Access Compliance Report

Public Rights-of-Way

Intersection ID: 28044	Main Street: TOM_SHORT_RD	Cross Street: ARDREY_KELL_RD	Location: S
ADA ID: E3B93A868911	Ramp Type: PerpDiag	Initial Pass/Fail: Fail	Overall Compliance: No
Severity Score: 21.25			
Codes/Mitigation Info/Possible Solution		Field Measurements/Component Compliance

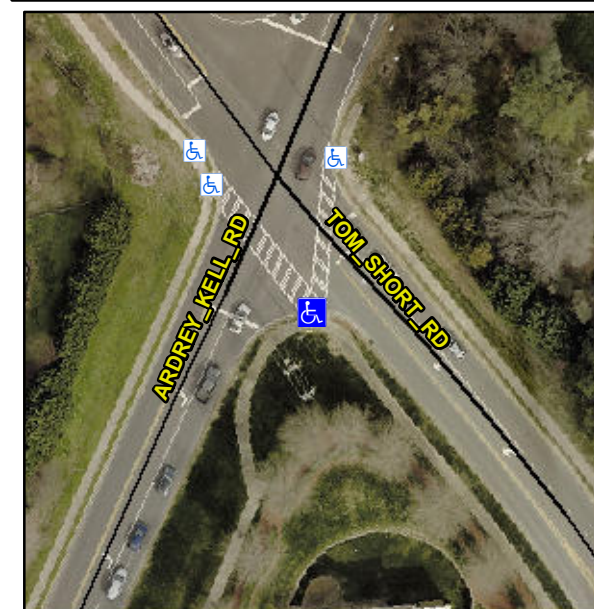
R304.5.1, R304.5.3

Compliance	Description	Data	Compliance	Description	Data
N/A	Ramp Length (in)	95.0	Yes	Ramp Slope (%)	7.2
No	Ramp Width (in)	47.0	No	Ramp XSlope (%)	6.0
N/A	Flare Type LT	N/A	N/A	Flare Type RT	N/A
N/A	Flare Slope LT (%)	N/A	N/A	Flare Slope RT (%)	N/A
N/A	Flare Traversable LT?	N/A	N/A	Flare Traversable RT?	N/A
N/A	Landing Length (in)	N/A	N/A	DWS Provided?	N/A
N/A	Landing Width (in)	N/A	N/A	DWS Contrast?	N/A
N/A	Landing Slope (%)	N/A	N/A	DWS Length (in)	N/A
N/A	Landing X Slope (%)	N/A	N/A	DWS Full Width?	N/A
N/A	Landing Curb? (Y/N)	N/A	N/A	DWS Offset (in)	N/A
N/A	Shared Landing?	N/A			
N/A	Gutter Ponding?	N/A	N/A	Gutter Slope (%)	N/A
N/A	Gutter Lip Ht (in)	N/A	N/A	Gutter X Slope (%)	N/A
N/A	Painted X Walk1?	No	N/A	Painted X Walk2?	No
	X Walk 1 Direction	To NE		X Walk 2 Direction	To NW
N/A	X Walk 1 Width (in)	N/A	N/A	X Walk 2 Width (in)	N/A
	X Walk 1 Slope (%)	2.6		X Walk 2 Slope (%)	2.1
	X Walk 1 X Slope (%)	2.9		X Walk 2 X Slope (%)	2.6

N/A	Ramp inside XWalk1?	N/A	N/A	Ramp inside XWalk2?	N/A
	Road Slope (%)	1.1	N/A	Clear Space?	N/A
	Road X Slope (%)	1.8	N/A	Clear Space to XWalk (in)	N/A
N/A	Any Obstructions?	N/A	N/A	Storm Grate/Utility Hazard?	N/A
	Obstruction Type			Storm Grate/Utility Type	
		N/A			N/A
		Yes		Surface Condition? (G/P)	Good

Remove & Replace Curb Ramp With Two New Directional Ramps or Equivalent.
